ZEE Systems, Inc.

SERVICE BULLETIN 6386-1

A. Effectivity: All SZ58-003-Series and Z99-800-Series Motors with Z6386A Brushes (Z6386AK Brush Kit) installed prior to August 12, 2003.

B. Reason: Brush Z6386A (included in Z6386AK Kit) shipped before 8-12-03 have a insulation sleeve over the copper wire strands between the terminal lug and the carbon contact. In some cases this sleeve causes the brush to hang up in the brush holder and lose contact with the armature commutator. This condition causes the motor to turn slower and pull a higher than expected current draw which in some cases causes the current limiter and or circuit breaker to trip. This condition does not present any danger to flight.

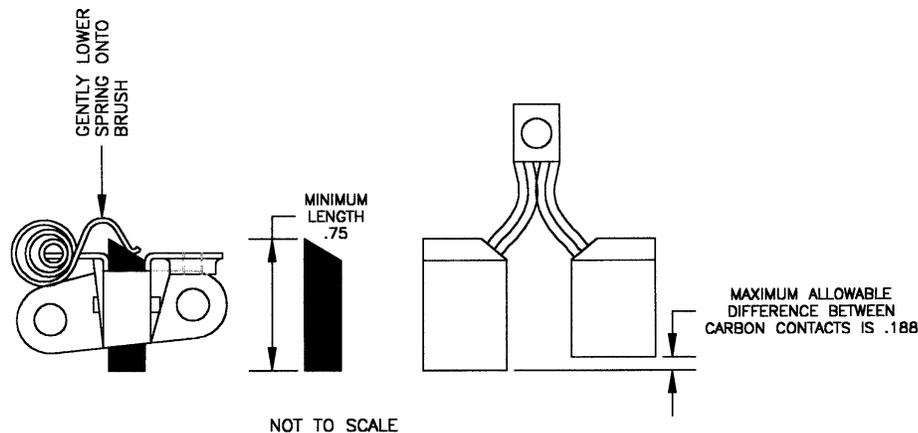
A. Inspection: Remove the two brush covers on the motor.

1.0 If brush assemblies do not have the white insulation no action is required. Replace brush covers and return the motor to service. Note compliance with this service bulletin.

2.0 If brush assemblies have a white insulation tube remove each brush assembly. Mark each brush assembly to insure each brush is returned to the same holder.

B. Modification: Using a razor blade cut along the insulation. Take care not cut into the copper wire strands. Discard the insulation (2 per brush assembly).
